# Borough President Recommendation

Application: C 120380 ZMM

**Recommendation on**  
**ULURP Application Nos. C 1203080 ZMM, & N 120381 ZRM –**  
**Special Hudson Square District by**  
**The Rector, Church-Wardens and Vestrymen of Trinity Church in the City of New York**

**APPENDIX B:**  
Proposed Alternative Massing

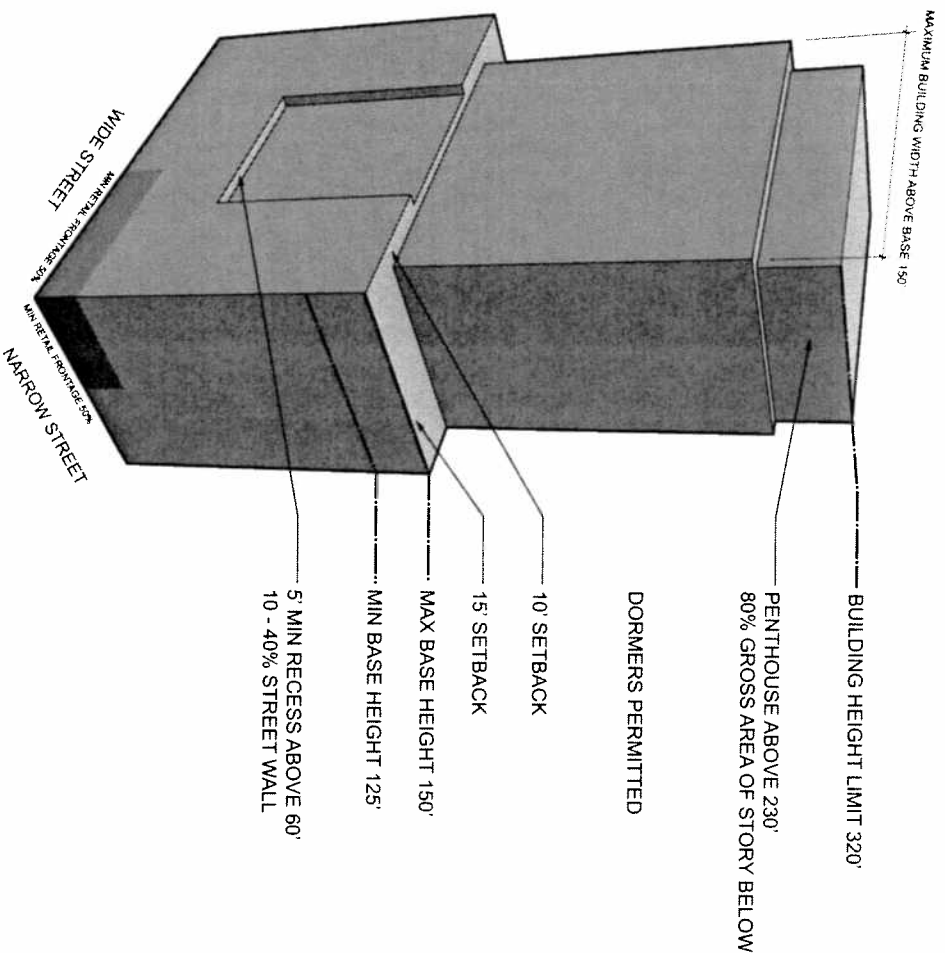
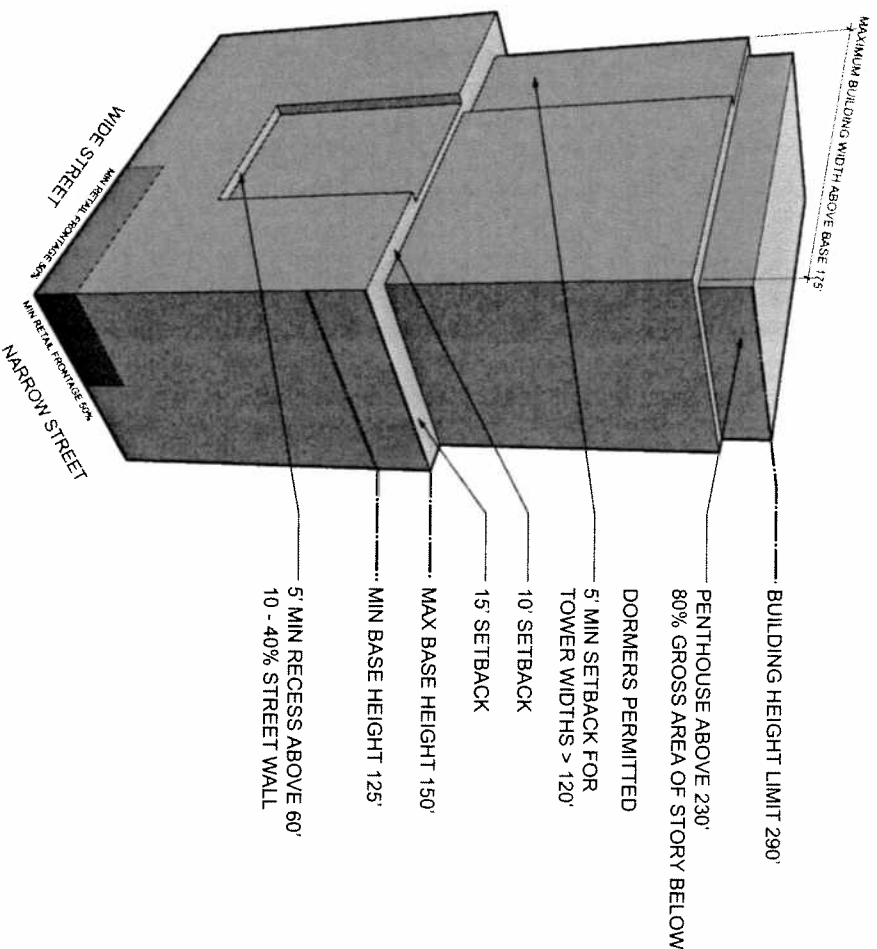
The rationale to raise the building height to 320 feet is that new buildings would be limited to a width of 150 feet above the base. This regulation moves bulk vertically rather than horizontally. While this bulk control is intended to break up the building's mass, alternative urban design controls with a lower height limit could be implemented to achieve a similar goal.

Instead of a narrow tower, the tower could be allowed to widen, and set back another five feet for a portion of the tower, which would create two planes to break up the building's mass. By allowing the building's tower to be 175 feet wide instead of 150 feet wide above the base, the total height of the proposed building could be reduced to 290 feet, while maintaining an average of 11 feet floor to floor heights. However, to ensure that the building's mass remains broken, the tower should be broken up to two segments. A portion of the building fronting wide streets no greater than 120 feet should be required to set back 10 feet and the remaining portion should be required to set back 15 feet. Narrow street setbacks should remain at 15 feet.

1. **Reduce the height on the avenues to 290 feet by widening the proposed tower portion on the base to 175 feet wide, and require an additional setback for the portion of the tower greater than 120 feet wide;**
2. **Continue to pursue alterative language, which would eliminate Subdistrict B and allow it to follow the rules of the rest of the special district;**
3. **Remove the hotel special permit expiration, which would strengthen the special district;**
4. **Continue to work with the Borough President's office and the community to identify open space opportunities;**
5. **Work with the community on the design of Duarte Square Park;**
6. **Encourage the SCA to meet the needs and concerns of the community in planning the school;**
7. **Work with the SCA/DOE to ensure public access to the school's playground and other facilities during non-school hours.**

Height: Trinity is amenable to the adjustment of wide street heights in the district as studied and proposed in your recommendation letter.
